**Procurement of Plant Design, Supply, Delivery, Installation, Testing and  
Commissioning of  
Lot 1: 400 kV Ratmate Substation and works at Lapsiphedhi and New  
Hetauda Substations  
Lot 2: 400 kV  
New Butwal Substation  
Lot 3: 400 kV New Damauli Substation**

**MCA-N/ETP/CB/004**

**ADDENDUM #9**

**Issued on: 04 September 2023**

DRAWING NUMBER NBW-100-1

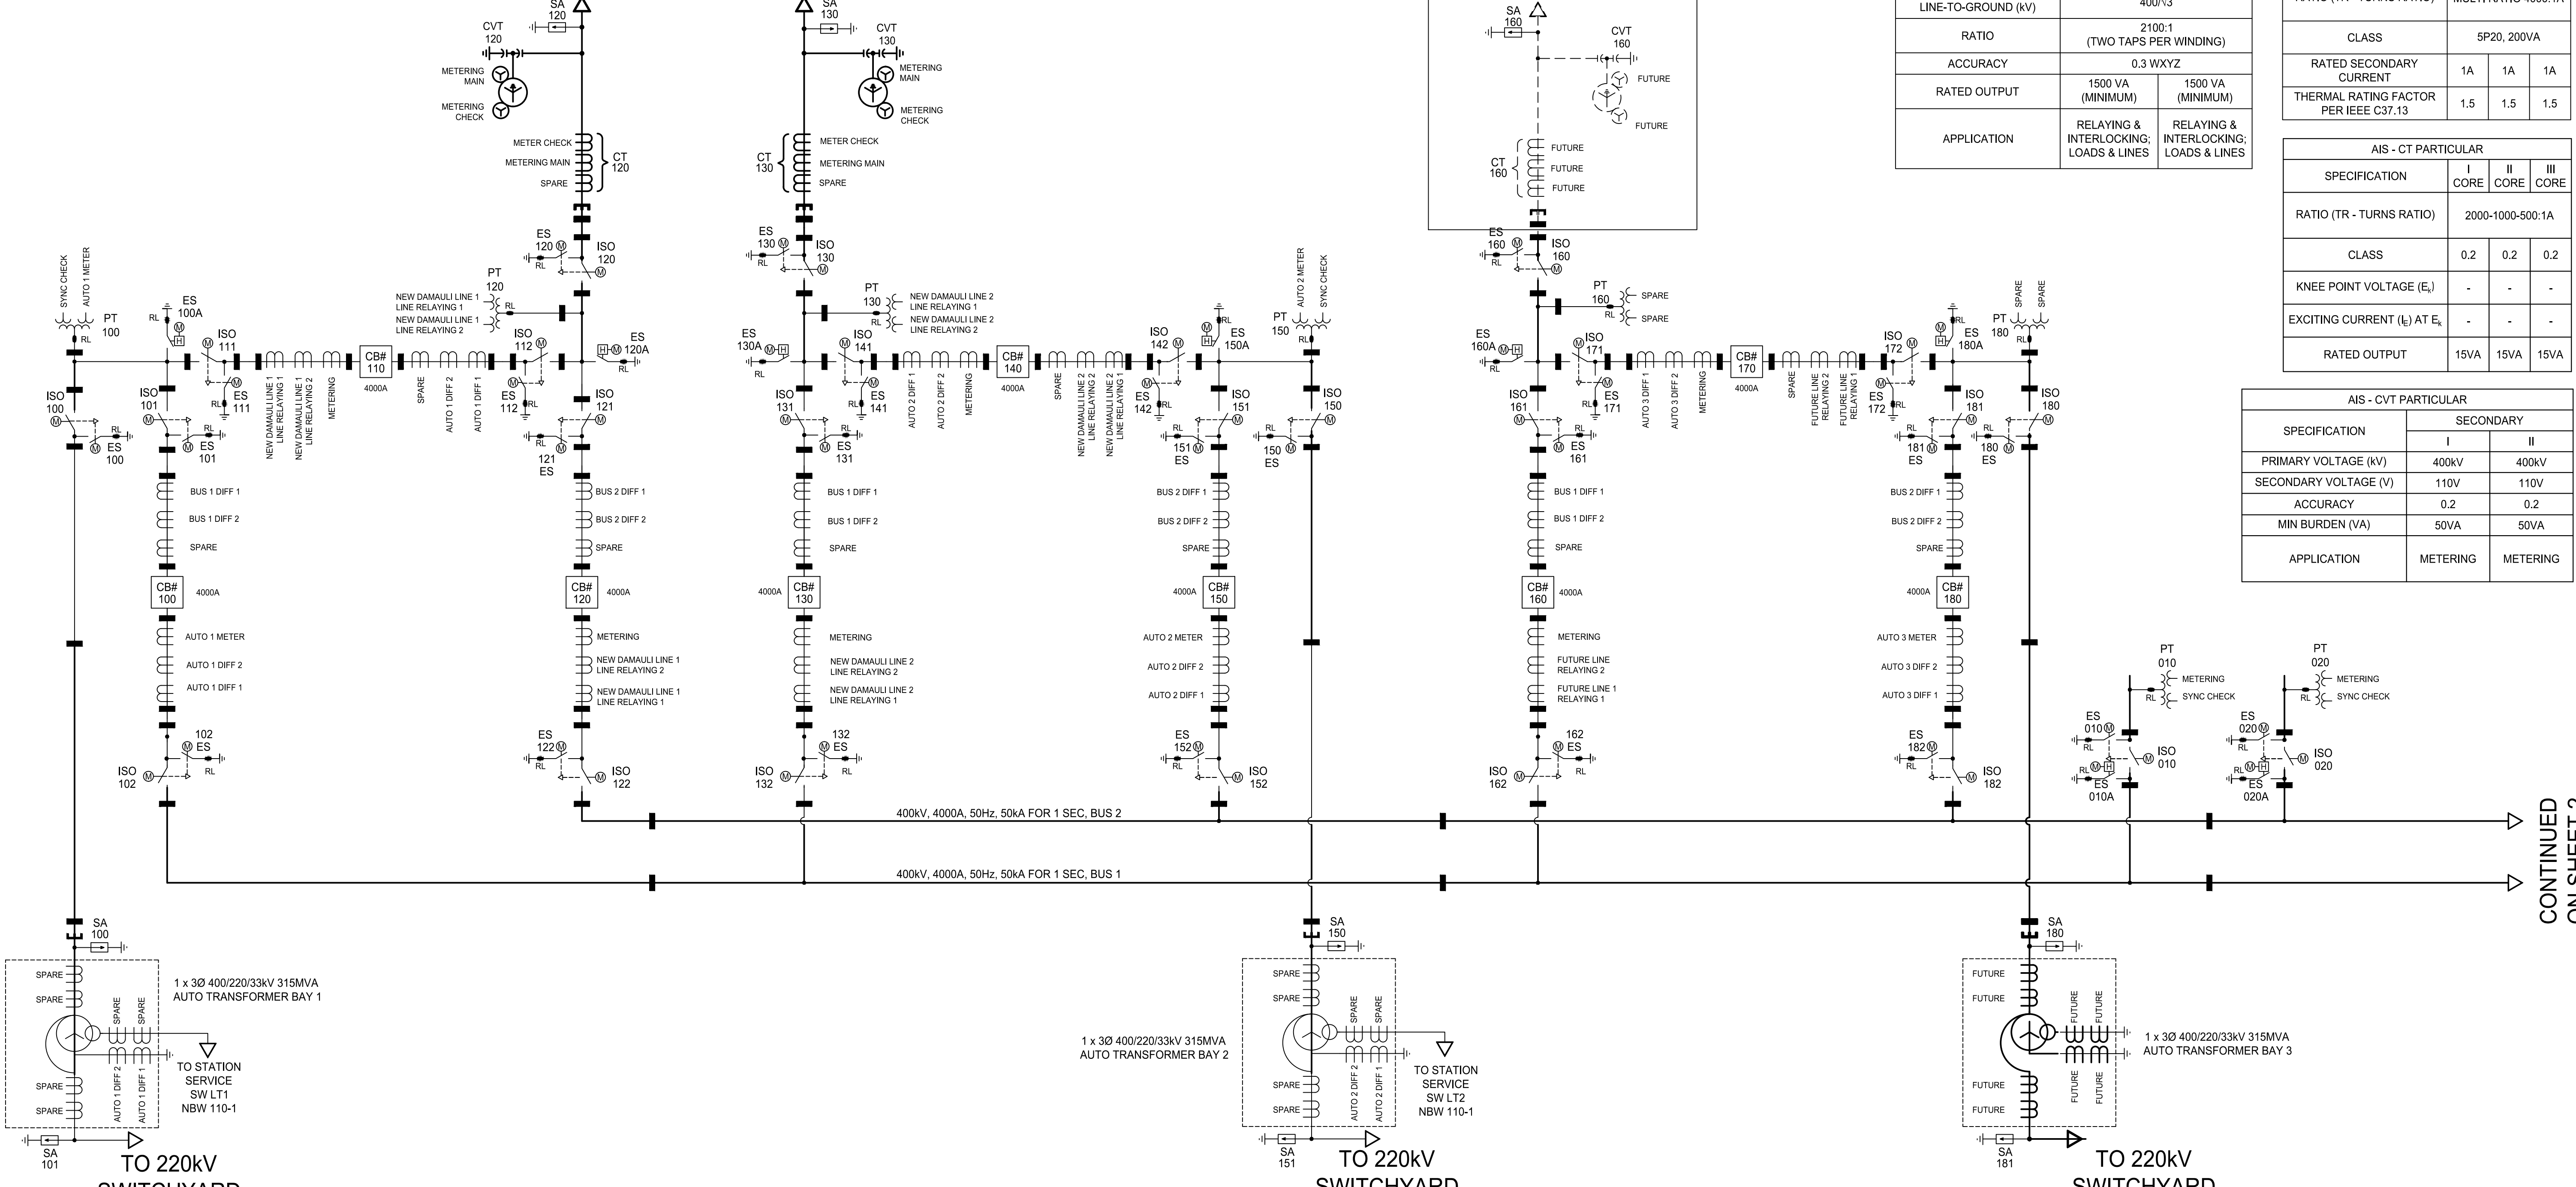
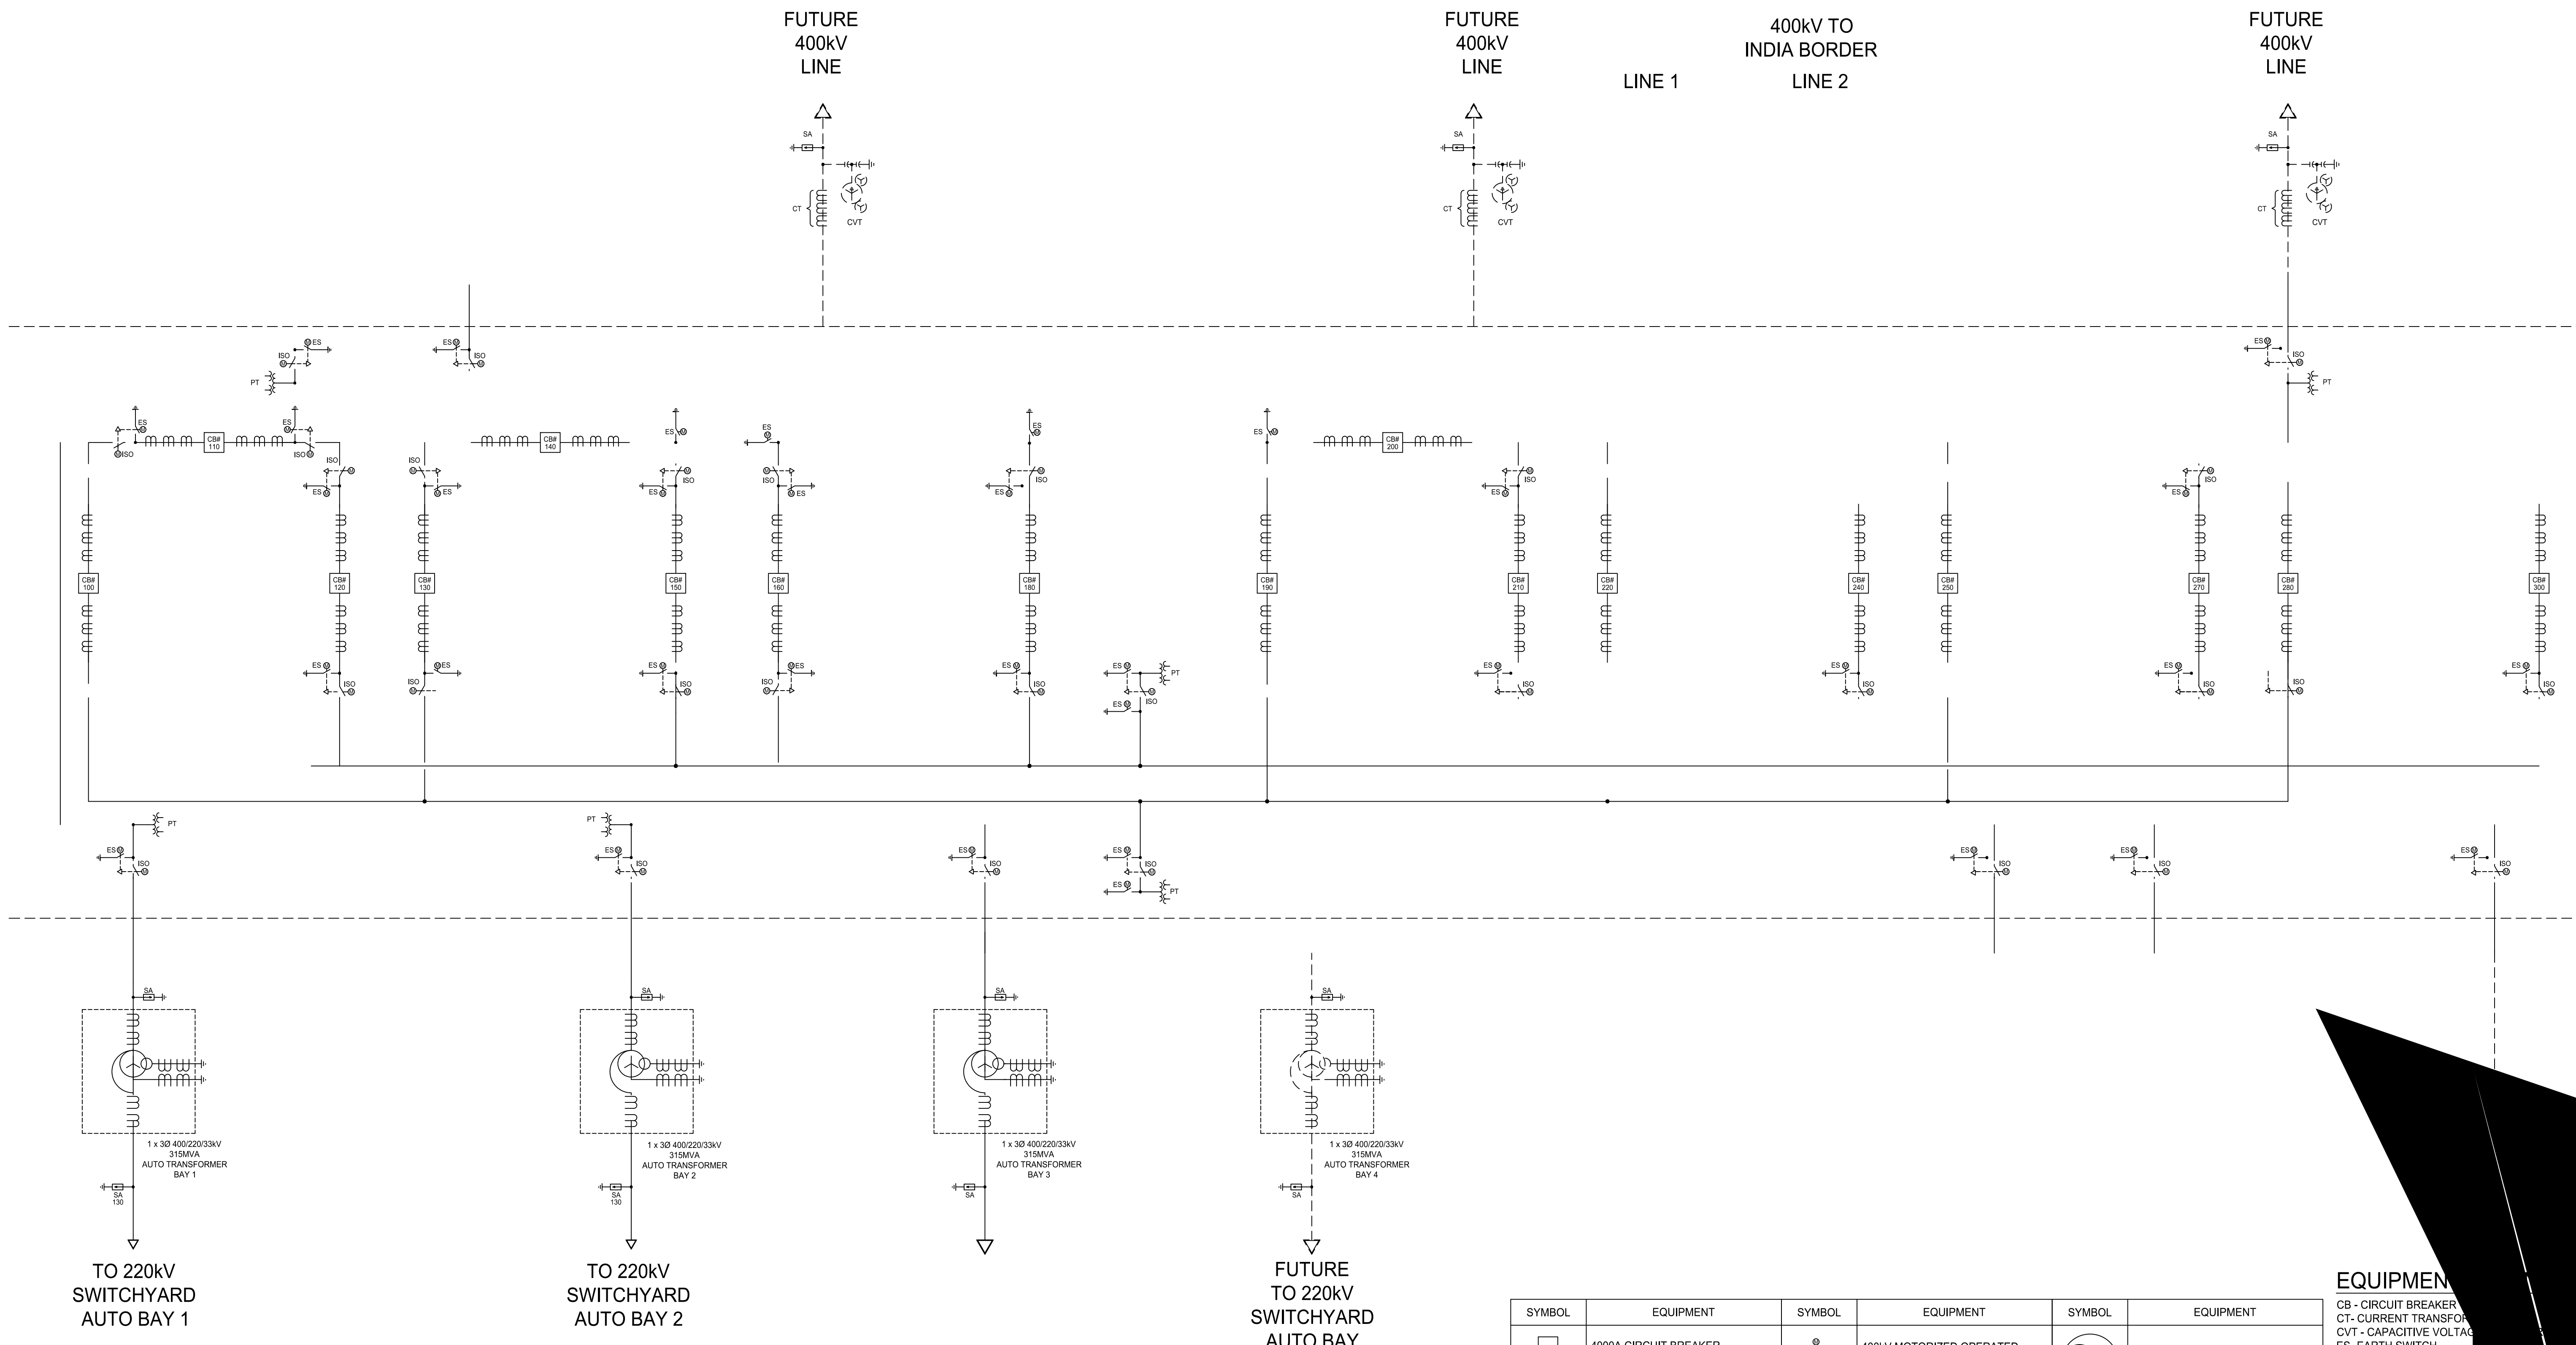
SN	Pages/Paragraph	Amendments
		<p><b>Scope of work. The Employer shall exercise either Base Scope, or part or full of Option Scope of work based on the fund availability.</b></p> <p>The detailed scope of work for Base and Option are clearly described in B1.1-Project Specific Requirement (PSR) of the bid document. The Bidders are requested to quote the price as per the price schedule attached in Section IV of bid document. <b>Irrespective of the Base Scope or Option Scope (or part of it) to be selected by the Employer,</b> the scope of work shall include construction of the entire GIS buildings, control buildings, station services, and site preparation and grading for the full scope of work, as shown on the single line and layout drawings.</p> <p><b>has been replaced by:</b></p> <p>Name of this procurement is:  <b>Procurement of Plant Design, Supply, Delivery, Installation, Testing and Commissioning of</b>  <b>Lot 1: 400kV Ratmate Substation and works at Lapsiphedhi and New Hetauda Substations,</b>  <b>Lot 2: 400kV New Butwal Substation and</b>  <b>Lot 3: 400kV New Damauli Substation</b></p> <p>Identification number of this procurement is: <b>MCA-N/ETP/CB/004</b></p> <p>The lots comprising this procurement are:  <b>Lot 1: 400kV Ratmate Substation and works at Lapsiphedhi and New Hetauda Substations,</b>  <b>Lot 2: 400kV New Butwal Substation and</b>  <b>Lot 3: 400kV New Damauli Substation</b></p> <p>1) The detailed scope of work is clearly described in B1.1-Project Specific Requirement (PSR) of the bidding document. The Bidders are requested to quote the price as per the price schedule attached in Section IV of the bidding document. The scope of work shall include construction of the entire GIS buildings, control buildings, station services, and site preparation and grading for the full scope of work <b>(i.e. Option Scope of work)</b>, as shown on the single line and layout drawings.</p>
